CONTINENTAL MOTORS® AIRCRAFT ENGINE
CRITICAL SERVICE BULLETIN
COMPLIANCE NECESSARY TO MAINTAIN SAFETY

Category 2
CSB07-2A

SUBJECT: Turbocharger Wastegate Oil Inlet Fitting Inspection and Replacement

PURPOSE: To provide instructions for the inspection of the turbocharger wastegate oil inlet fitting for possible chafing on the adjacent structure and to provide instructions for fitting replacement.

**FIGURE 1
INSPECTION AREA**

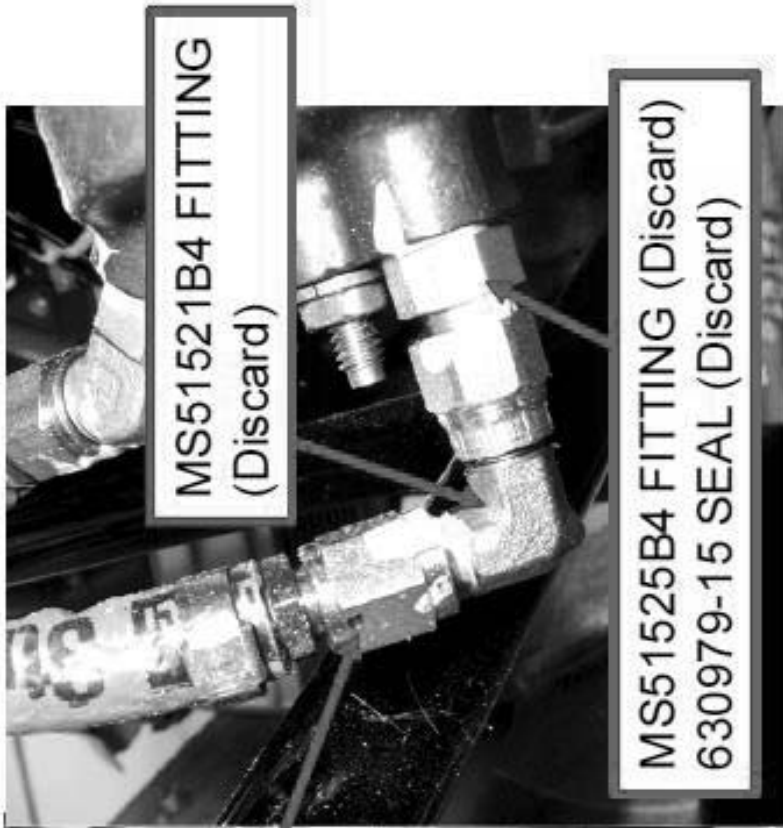
1. Using the airframe manufacturer's maintenance instructions, open or disconnect each engine cowl flap to allow access to the wastegate actuator. (Reference Figure 1)
2. Inspect the oil inlet fitting of the wastegate actuator.
3. If the fitting is a one-piece 90° fitting as shown in Figure 2A, no further action is required. Reassemble the previously removed airframe components using the applicable airframe manufacturer's maintenance instructions. Make engine log book entries for each engine inspected certifying compliance with this Critical Service Bulletin.
4. If the fitting is a two-piece assembly (straight fitting and 90-degree fitting) as shown in Figure 2B, proceed to the fitting replacement instructions contained in this Critical Service Bulletin.

1. Using the airframe manufacturer's maintenance instructions, open or disconnect the engine cowl flaps and remove the engine cowling as necessary to allow access to the wastegate actuator. (Reference Figure 1)

**FIGURE 2B
OLD INSTALLATION**

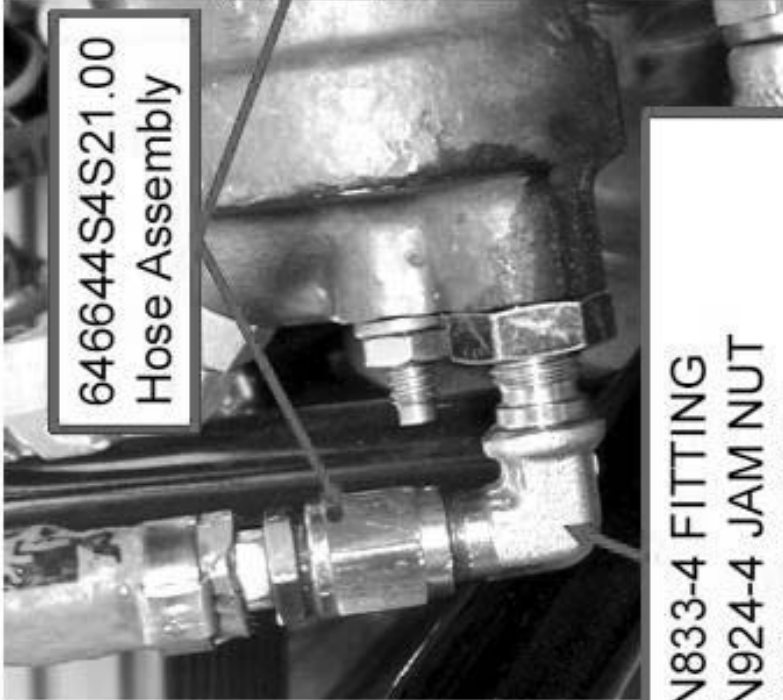
Continental Motors (CM) has received a report from the field of possible interference between the turbocharger wastegate oil inlet fitting and the adjacent airframe engine mount structure. Damage to the wastegate oil inlet fitting could lead to fitting fracture and subsequent loss of engine oil.

6. Install replacement 90-degree fitting P/N AN833-4 with new O-ring P/N 630979-15 (O-Ring P/N MS28778-4 is an approved alternate) and jam nut P/N AN924-4. Lightly lubricate the O-ring with clean 50W engine oil before installation.

7. Clock the P/N AN833-4 fitting to allow connection of wastegate oil pressure hose while maintaining sufficient clearance between the fitting and the airframe engine mount structure. While holding the fitting in position to ensure clearance between the fitting and the airframe engine mount structure, ensure that the O-ring is seated in the relief boss on the fitting. Screw

the jam nut finger tight against the fitting boss. Torque the jam nut to 85-105 inch-pounds while holding the correct fitting orientation.

Figure 3
FITTING REPLACEMENT DETAIL

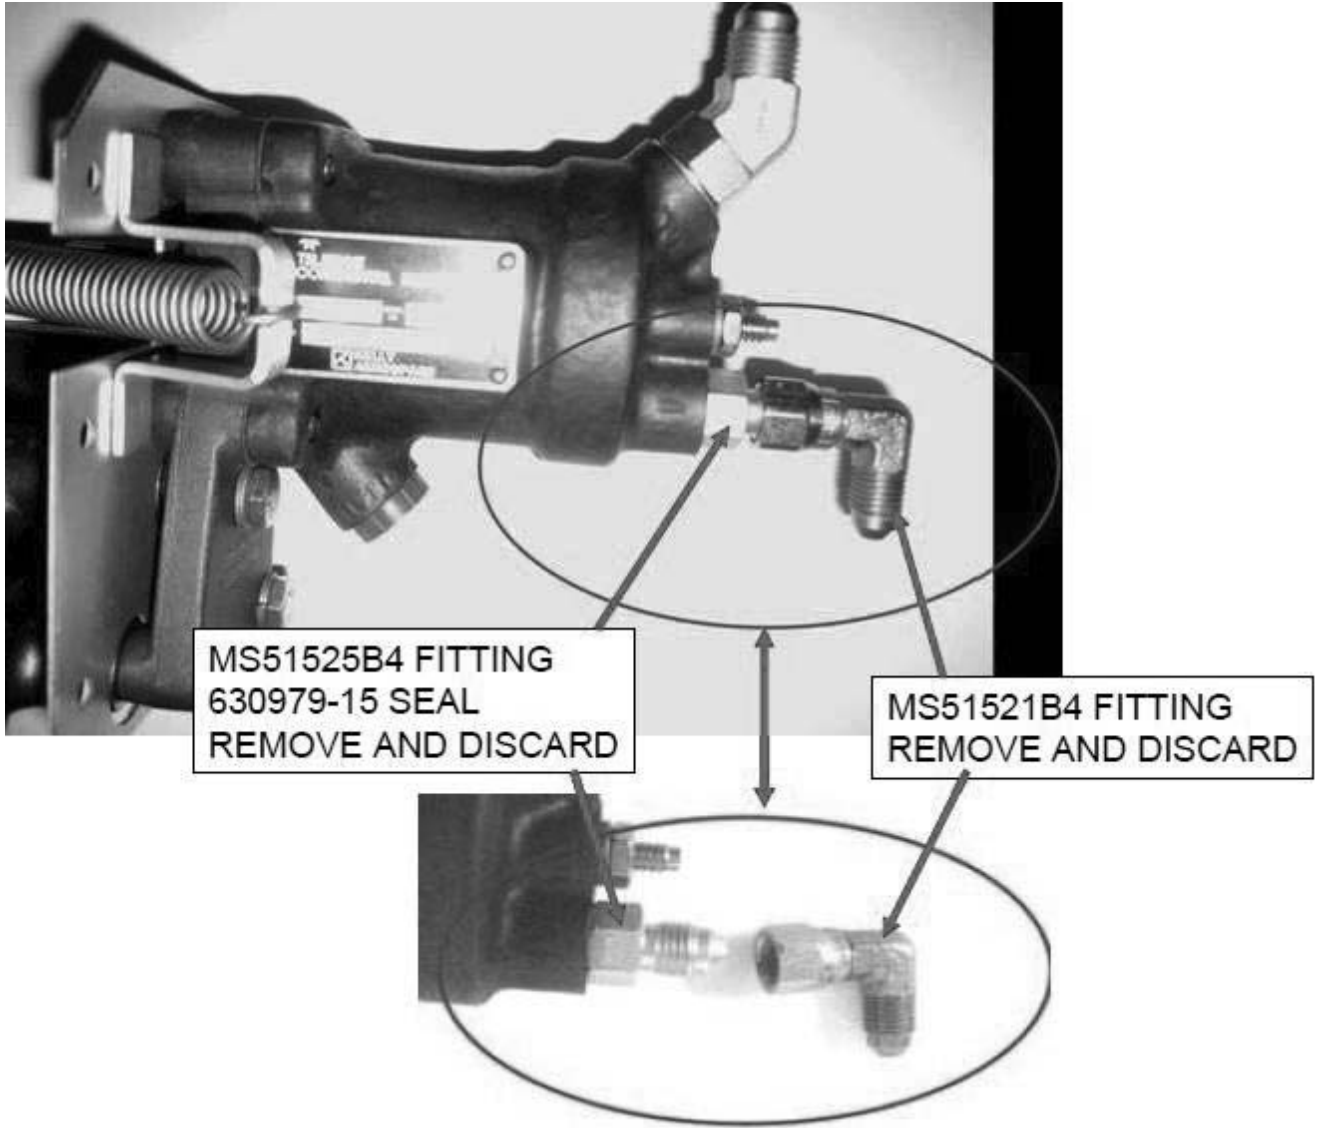
3. Remove the 90-degree fitting P/N MS51521B4, straight fitting MS51525B4, and O-ring seal P/N 630979-15 from the oil inlet on the wastegate and discard. (Reference Figure 3)
